Staff Report

Infill Housing Design Review Committee

File Number: 2-D-25-IH

Location: 3343 Divide St. Parcel ID 81 P B 001

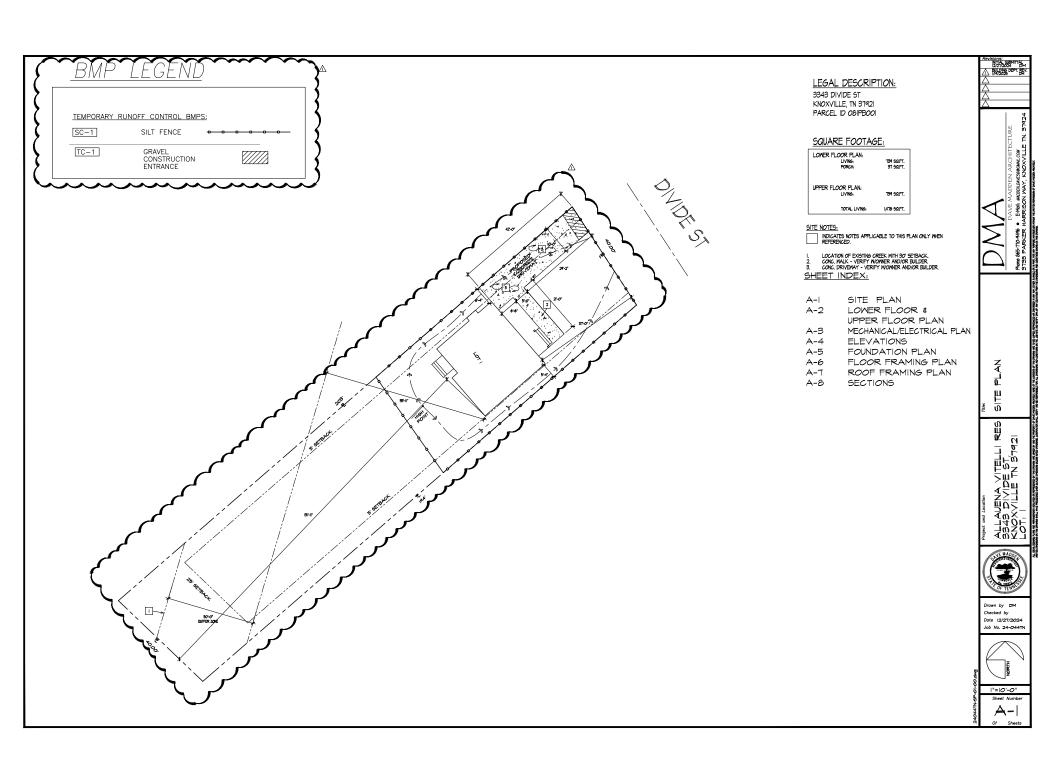
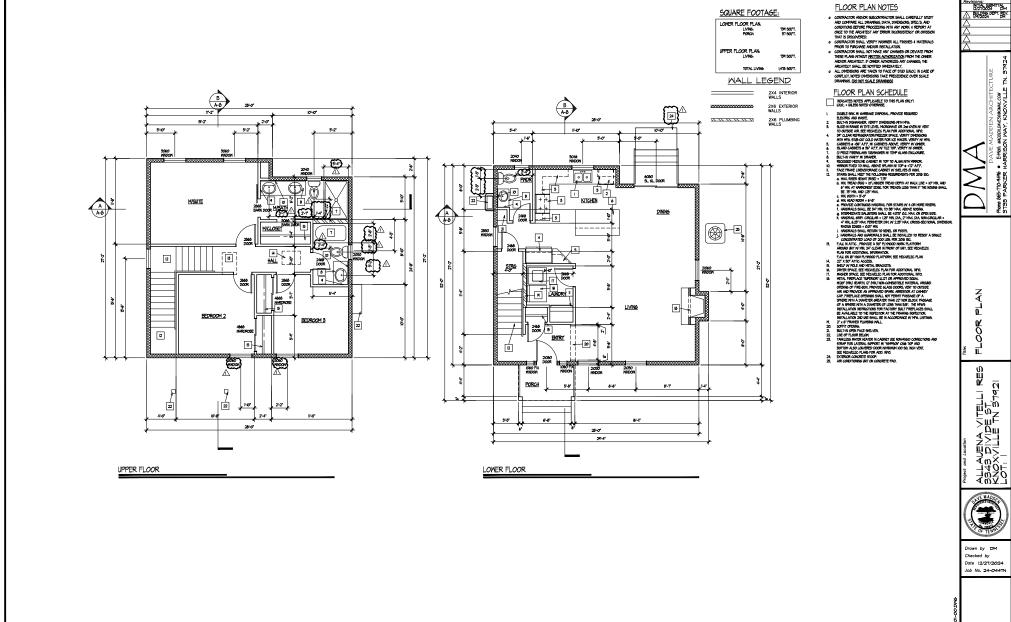
- 1. The house is proposed to be set 40'-8" from the front property line. The final site plan should be revised so that the front walkway connects to both the street and the driveway.

- 2. The block to receive new construction lacks significant context, as almost all the houses on the street are infill construction, interspersed with Minimal Traditionals and vacant lots. The 28' wide by 27'-2" deep house is not proportionate to the other houses on the block. The infill houses are rectangular in plan and are approximately 28' wide and 40' deep or 44' wide and 28' deep, and most nearby houses on 40' wide lots range in width from 16'-25.' The house also does not meet the minimum interior side setbacks required by the base zoning, so a variance would be required if this plan moves forward, and the rear setback requirements would allow for a house with a narrower width and larger depth.

- 3. Infill Housing design guidelines recommend that on lots without alleys, new driveways should be at least 20' behind the front façade of the infill house with access limited to one lane between the street and the front façade. Parking is a concrete pad located in front of the house and accessed via a driveway from Divide Street. Parking should be revised to avoid the front yard.

- 4. The two story, three-bay façade is not similar in scale and height to the context, which almost exclusively features one-story houses with balanced façades.

- 5. The house features a 6'-8" wide, 4'-4" deep front porch recessed under a front-gable roof and supported by two square wood posts. Guidelines state that front porches should be proportional to other houses on the block and at least 8' deep. The porch depth should be revised to at least 8', and the porch width should be increased to be proportional to the other houses on the block.

- 6. Guidelines recommend window and door styles be similar to historic houses on the block, with similar placement and ratio of solid to void. The façade should be revised to omit the half-shutter on the left first story window. The 4/4 single-hung windows are compatible with the 6/6 single-hung windows on most houses in the block, and the façade and rear elevations feature a sufficient ratio of solid to void. However, the house features five different window sizes, and the windows are placed at different heights on the side elevations, leaving large swaths of siding. The window sizes and placement should be revised to be more cohesive. The paneled door flanked with sidelights is appropriate.

- 7. The 8/12 roof pitch matches the neighborhood context.
- 8. The asphalt shingles meet the design guidelines. The foundation appears to be a concrete slab, which should be clad in stucco or parge-coated to meet the design guidelines. Guidelines discourage the use of vertical siding, and board-and-batten siding can be used only as a decorative element, such as in gable field. The siding should be revised to clapboard-style lap siding.

9. The final site plan should be revised to include a native or naturalized shade tree in the front and back yards.

Staff recommends postponement of Certificate 2-D-25-IH to allow the applicant to select another plan which more clearly meets the design guidelines (specifically, requirements of the base zoning, building width and depth, porch, parking, and window placement).
